Confidential Service Bulletin

Insulated Bearing and Brush Kit

For units with LF2.0 drives

Order Number: CTV-SVC15B-EN

Figure 1. Photo of typical spark discharge damage in a bearing race

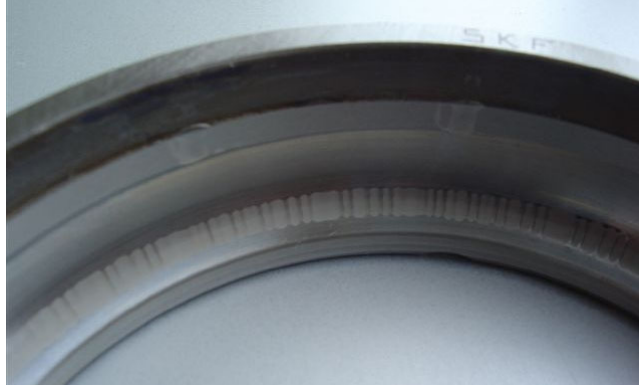
A situation may occur in some LF 2.0 equipped units where the chiller motor experiences a shaft voltage. The shaft voltage created may seek a path to ground through the thrust bearings, resulting in damage to the thrust bearing.

If a LF 2.0 AFD equipped chiller with steel bearing BRG01209 or BRG01210 is determined to have suffered a premature or repeat thrust bearing failure due to spark discharge, then Trane has available to install an insulated bearing assembly, a new design grounding brush, and a bearing inspection cover that allows the fitting of the new design brush.

For an LF 2.0 equipped chiller with a standard steel thrust bearing BRG01209 or BRG01210 that has failed due to spark discharge, with or without a brush kit: Order and install the insulated bearing assembly, new design brush, and (if needed) a new bearing inspection cover. See the parts ordering information below for details.

Figure 6. New design Bearing Inspection Cover with new design Grounding Brush installed.

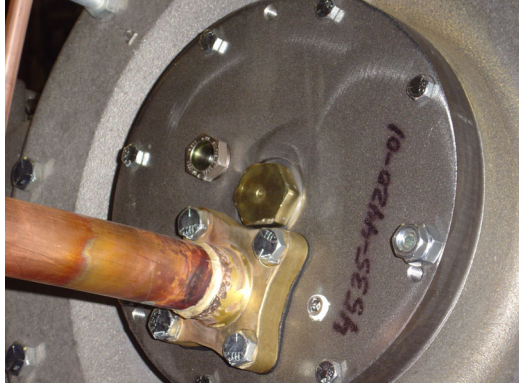
- Properly install the new bearing inspection cover onto the chiller.
- To install the new brush into the inspection cover, first remove the plug (if present) from the center fitting of the cover, then clean the threads. The threads and o-ring of the new style brush should be lubricated with Trane compressor oil OIL00022. The brush can then be inserted into the cover and tightened to a final maximum torque of 150 lb.-ft.
